REFERENCE: Docket 50-407
The University of Utah – TRIGA Research Reactor (UUTR)
License No. R-126

SUBJECT 3) : Detailed description of the change

Technical specification change is requested for Chapter 6.0. The change is: clarified the organizational chart, wording, and structure (main titles and subtitles) of the Chapter 6.0 to follow the ANSI/ANS15.1-2007 and ANSI/ANS15.4-2007. The following is detailed description of the changes:

Figure 6.1

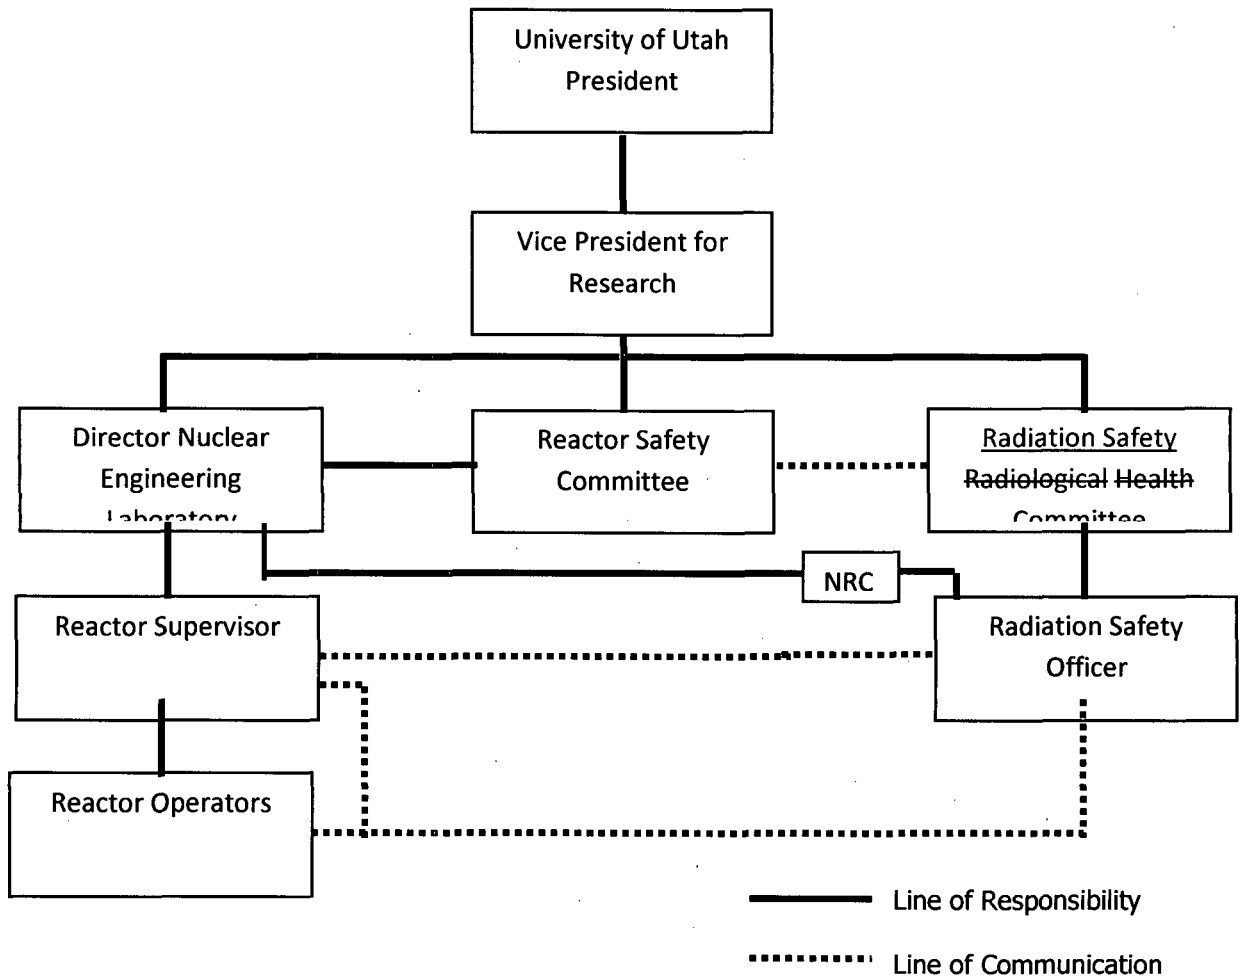
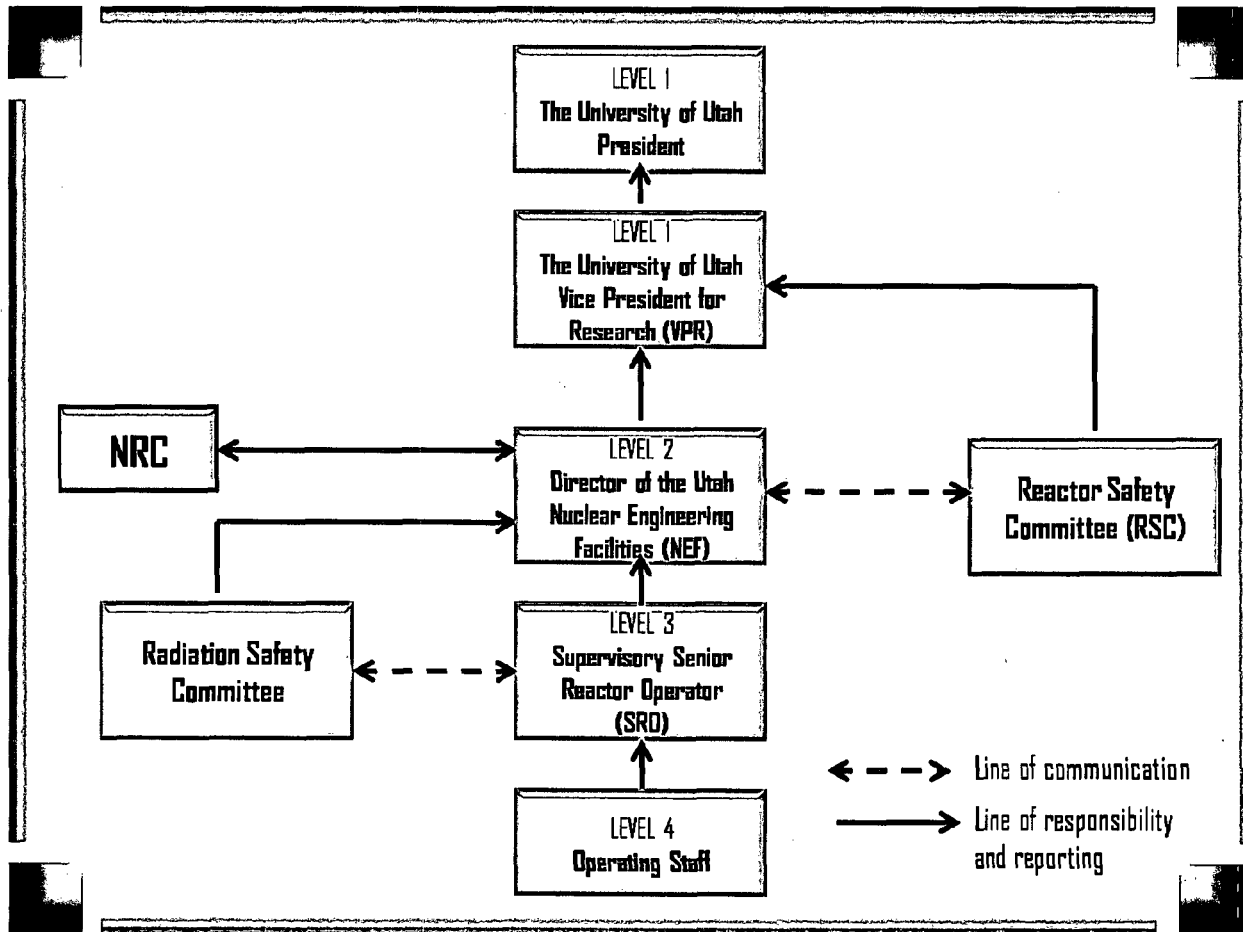
- 2) **Figure 6.1: Page 27 in the current TS, Chapter 14, Chapter 6.0**
The UUTR administrative organization flowchart was clarified to reflect clear administrative position, as well as to clarify the communication lines, and lines of responsibility and reporting.

University of Utah Administrative Organization for Nuclear Reactor Operations [Clarified - December 2009; in compliance with ANSI/ANS 15.1-2007]
